RHODE ISLAND DEPARTMENT OF TRANSPORTATION

Bridge Group 54A -Kingston Rd Bridge

NOTICE TO PROSPECTIVE BIDDERS

ADDENDUM NO. 2 Prospective bidders and all concerned are hereby notified of the following changes in the Plans, Specifications, Proposal and Distribution of Quantities for this contract. These changes shall be incorporated in the Plans, Specifications, Proposal and Distribution of Quantities, and shall become an integral part of the Contract Documents.

TYPICAL ABUTMENT SECTIONS
AND DETAILS SHEET 1

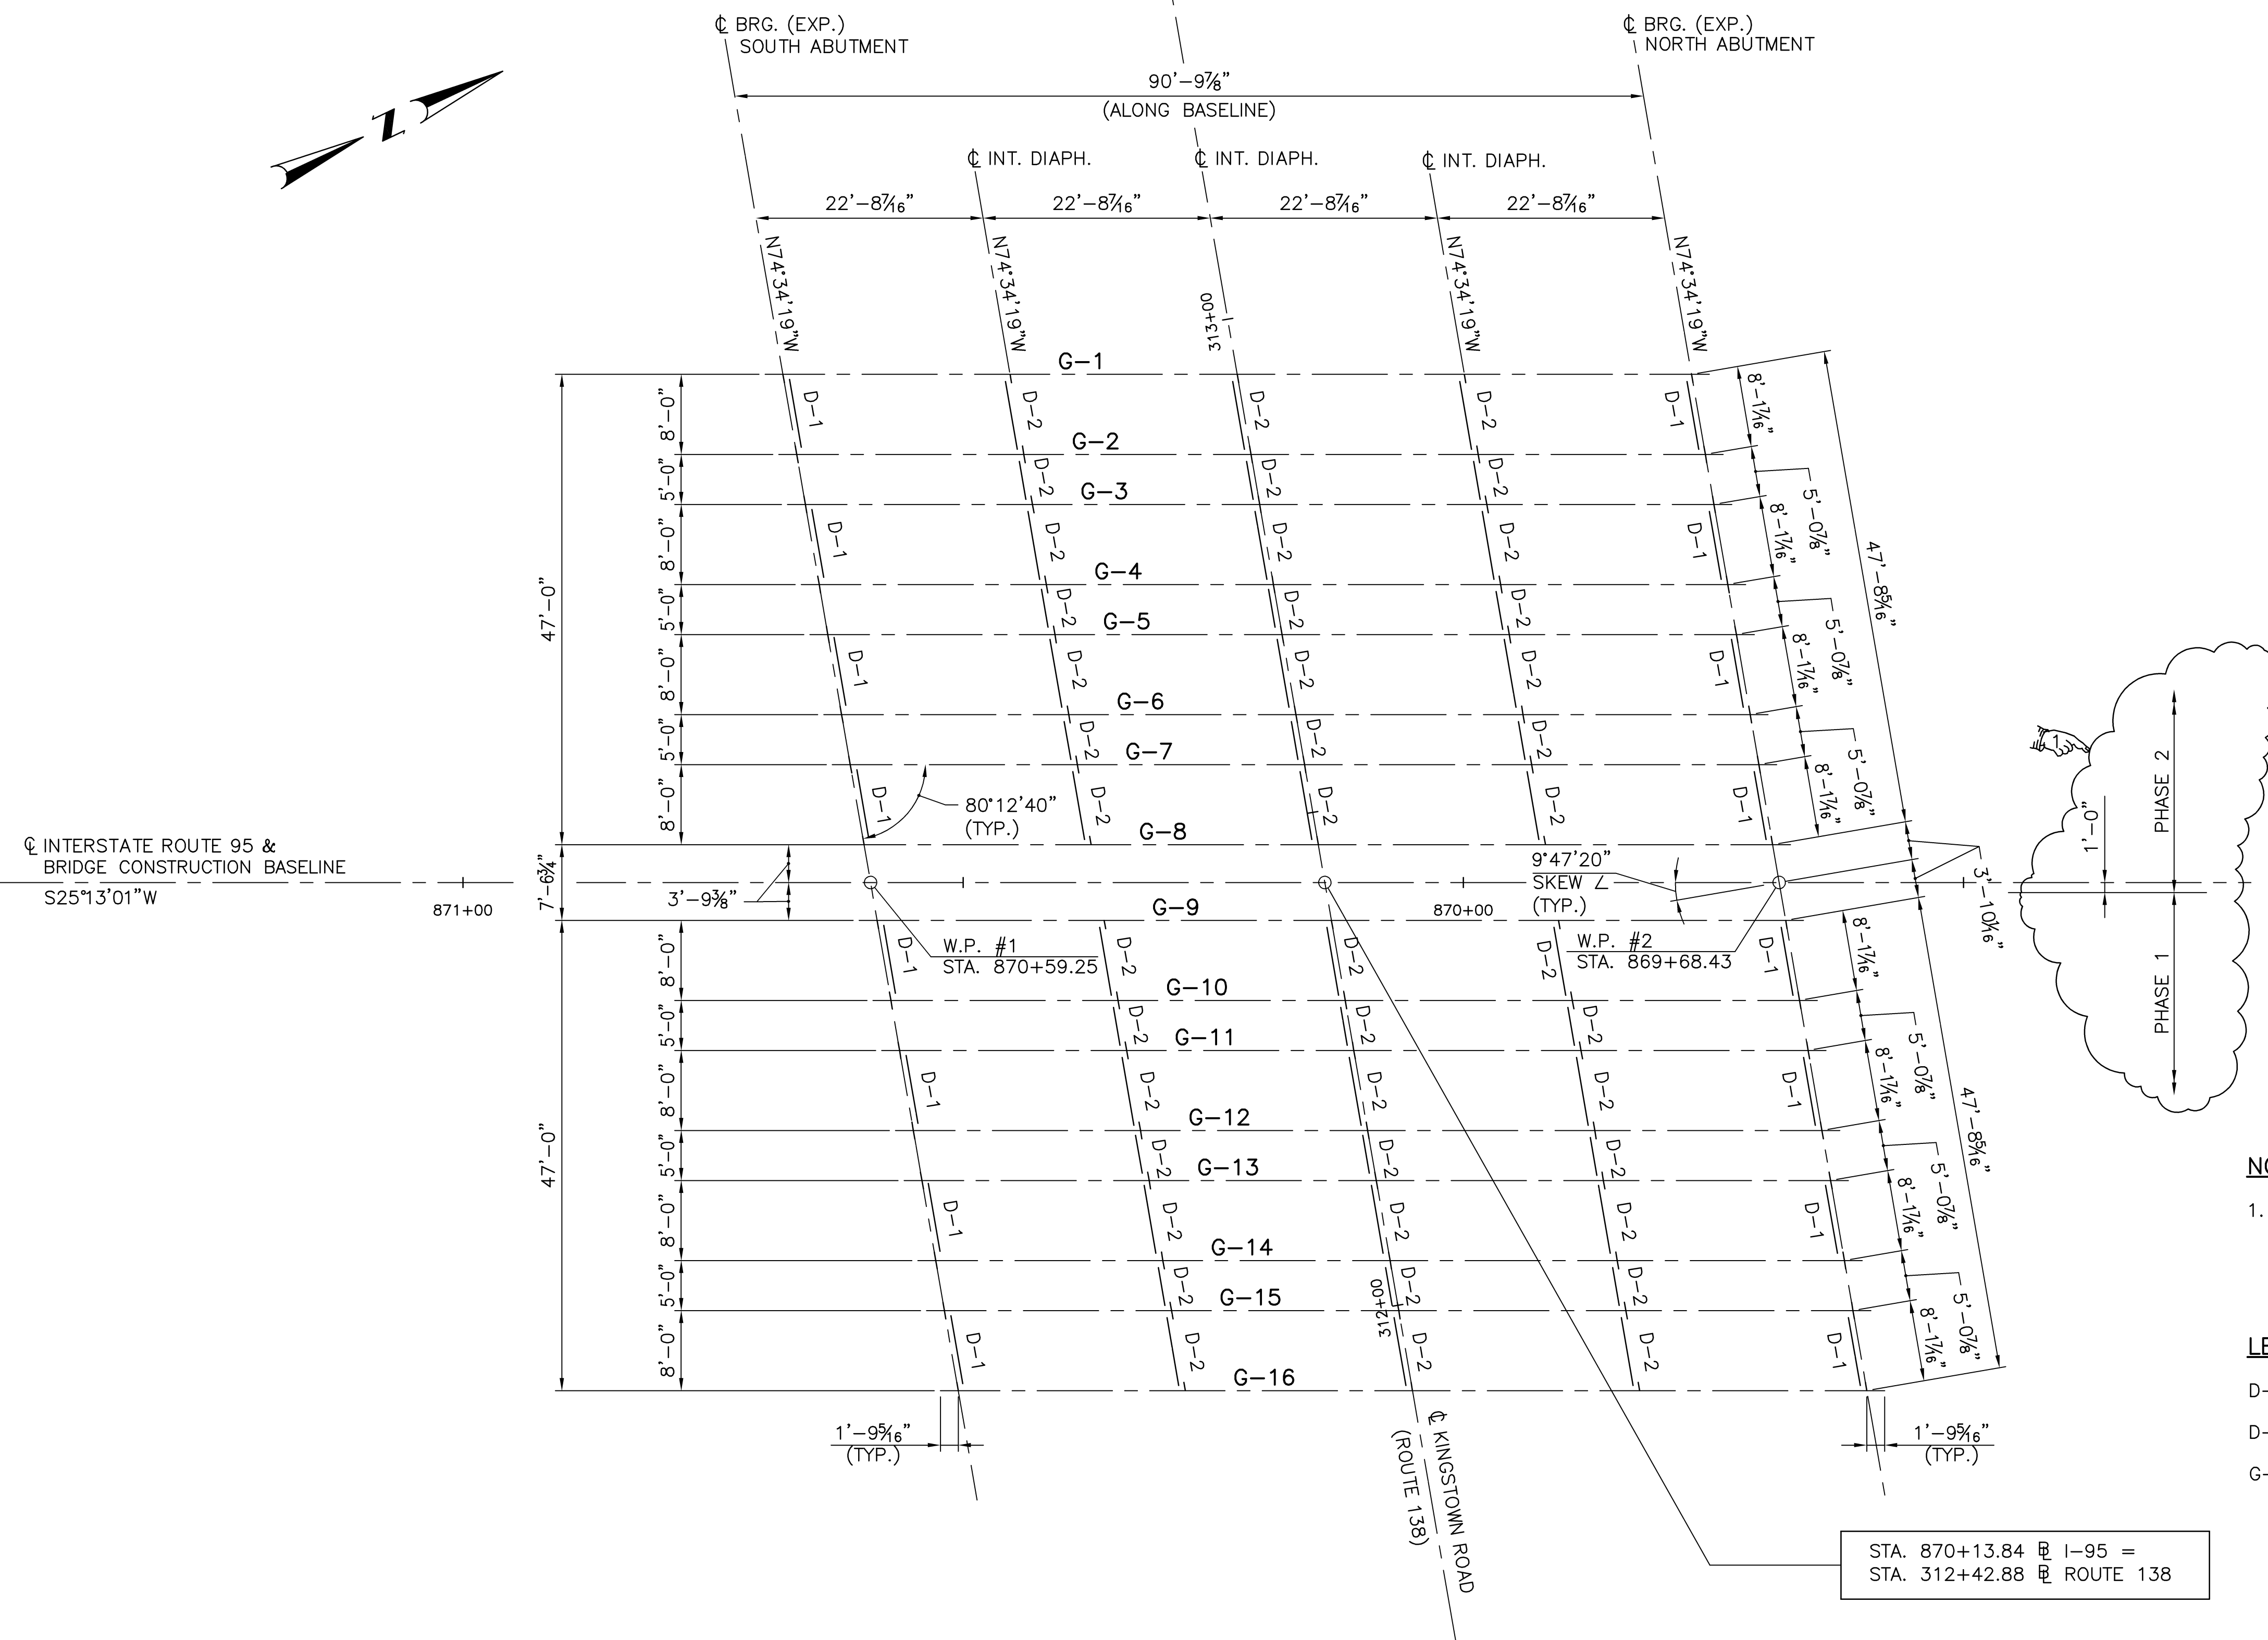
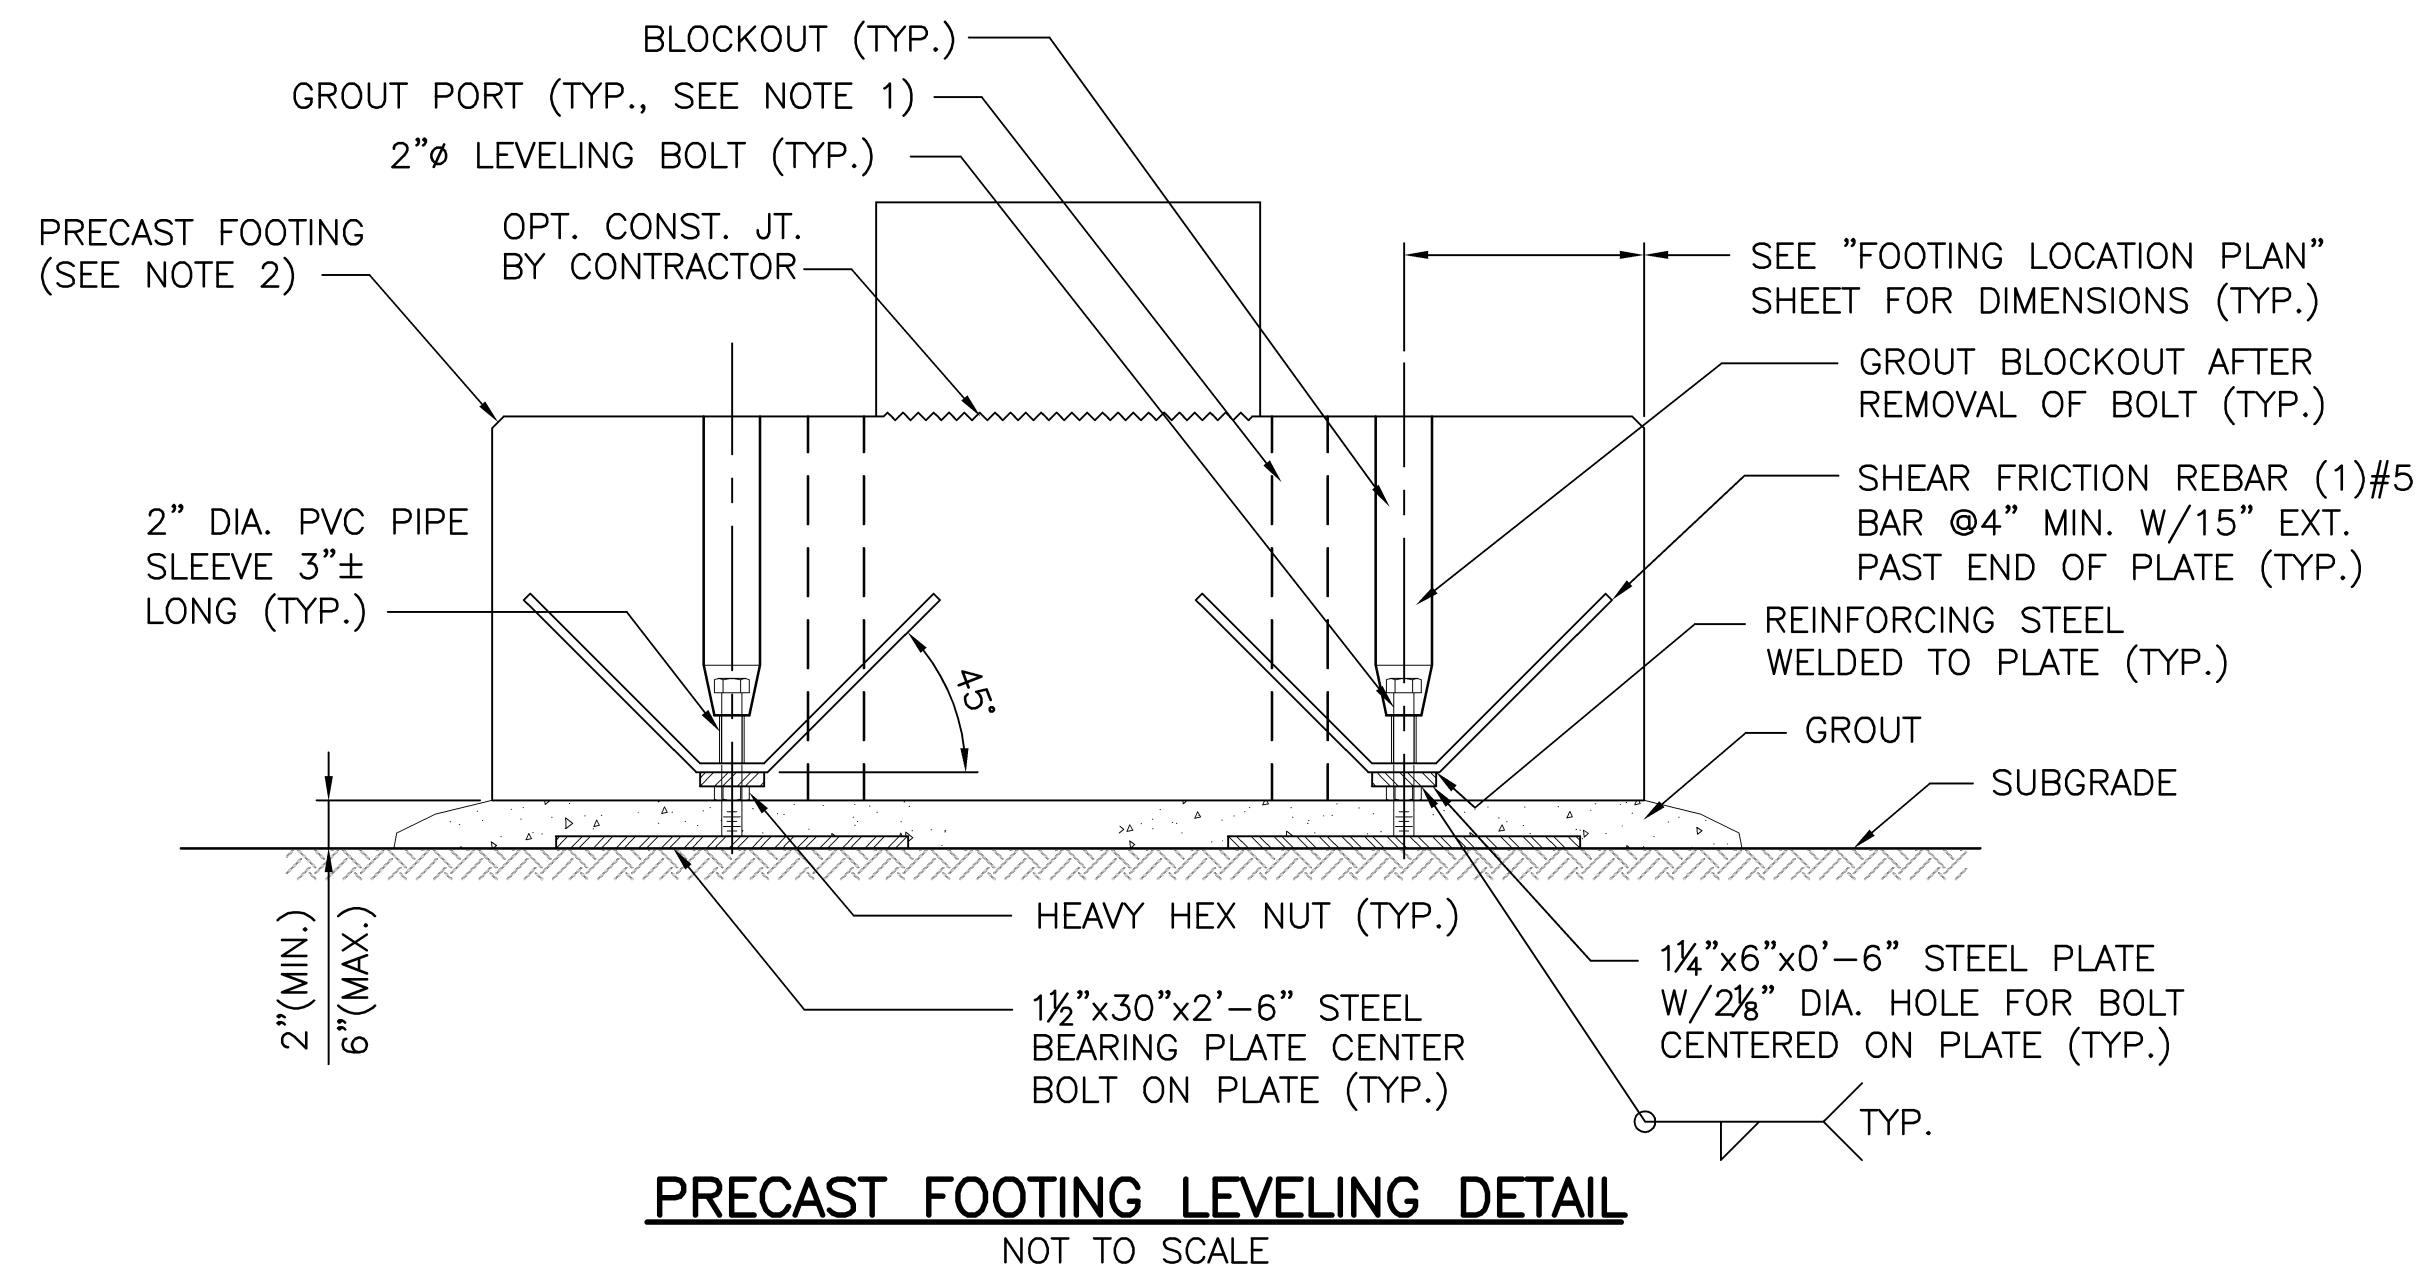
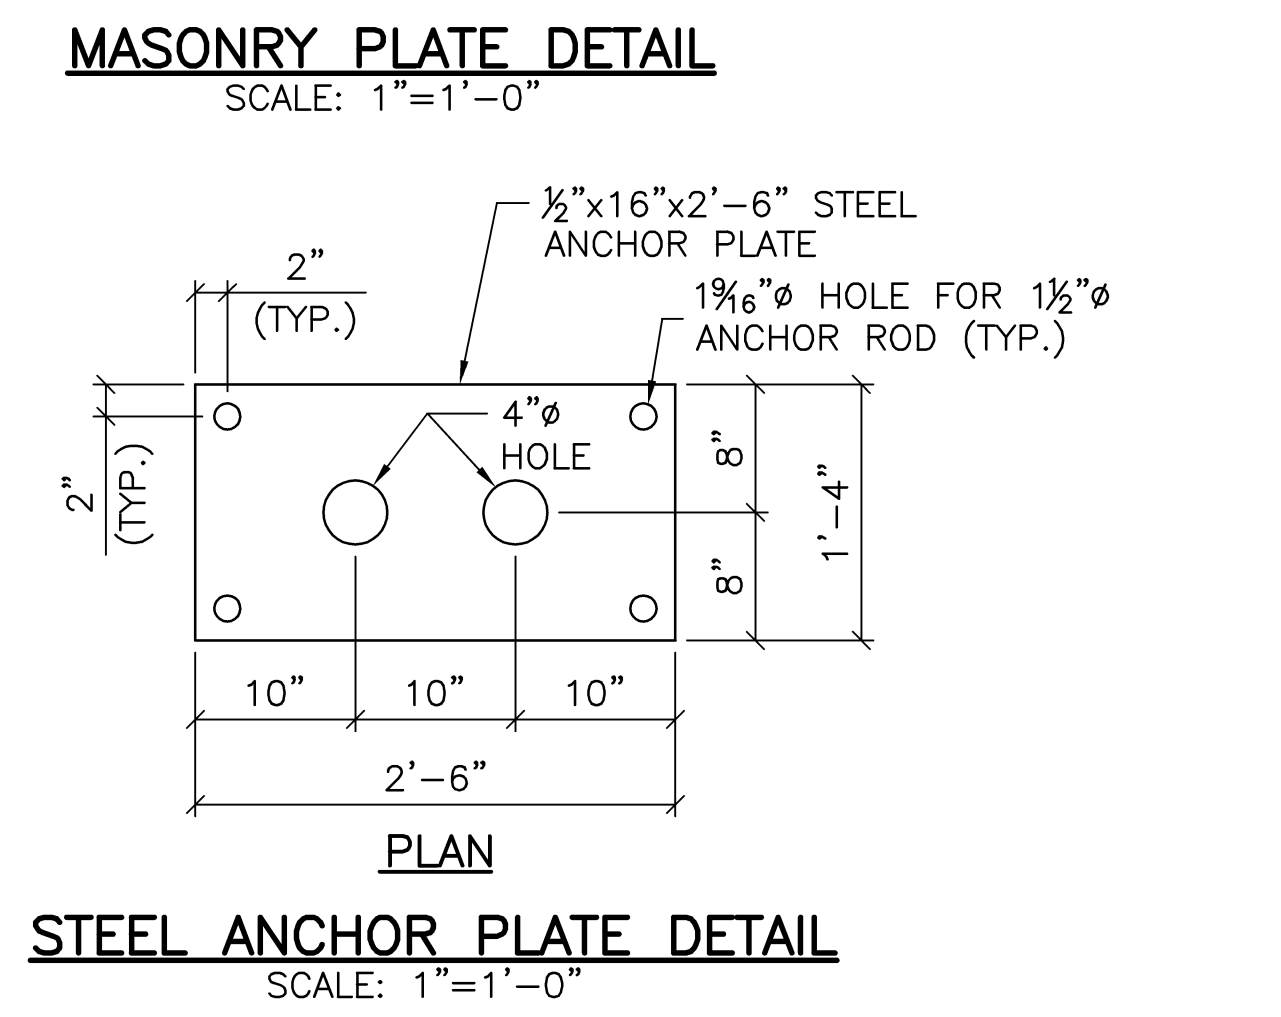
6. Volume 2 Plan Sheet No. 20 - Typical Abutment Sections & Details Sheet 1
Remove Volume 2 Sheet No. 20 in its entirety and replace it with revised Sheet No. 20 (R-1) attached to this Addendum No. 2. Typical Abutment Sections & Details Sheet 1 has been revised.
